Apartment Design Guide Assessment Table

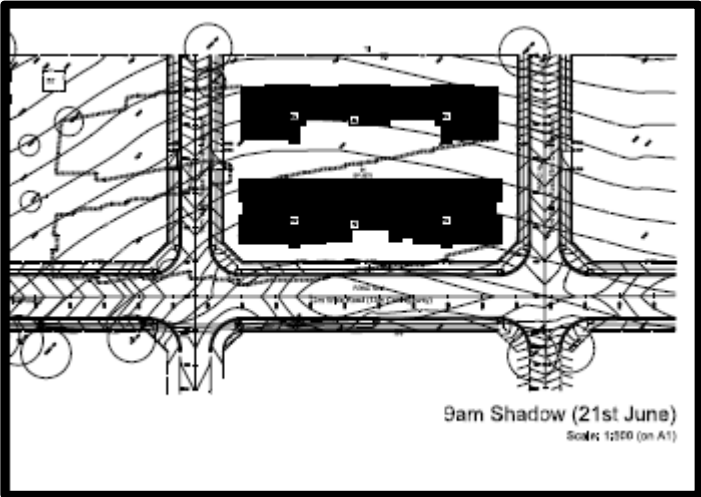
<u>3F-2 Visual Privacy</u> Site and building design elements increase privacy without compromising access to light and air and balance outlook and views from habitable rooms and private open space	Visual privacy is compromised between balconies upon building A at the northern and southern ends of the building upon levels 1 to 6 and building B at the northern end of the building upon levels 1 to 3, where balconies of adjoining units are separated	No

by approximately 4.4 metres without adequate screening to retain privacy for individual units.	
<u>3G-1 Pedestrian Access and Entries</u> Building entries and pedestrian access connects to and addresses the public domain <u>3G-2 Pedestrian Access and Entries</u> Access, entries and pathways are accessible and easy to identify	The residential lift lobbies of the western building (building B) face the raised up communal open space area rather than facing the street directly. This is not acceptable as it reduces entry legibility, street activation and address. The proposed building's, shall be accessible directly from the streets (i.e. Ingleburn Road and Road No. 2). The proposed entries from the internal courtyard are not acceptable.	No
<u>3H-1 Vehicle Access</u> Vehicle access points are designed and located to achieve safety, minimise conflicts between pedestrians and vehicles and create high quality streetscapes	The vehicular entry/driveway from Road No. 2 is exposed and is located between two buildings. The exposed basement ramp is considered to compromise the visual quality of the public domain and the ramp should be encapsulated into a built form. In addition, the proposed basement access width does not accommodate a 9.98m heavy rigid vehicle to allow for Council waste servicing of the site.	No
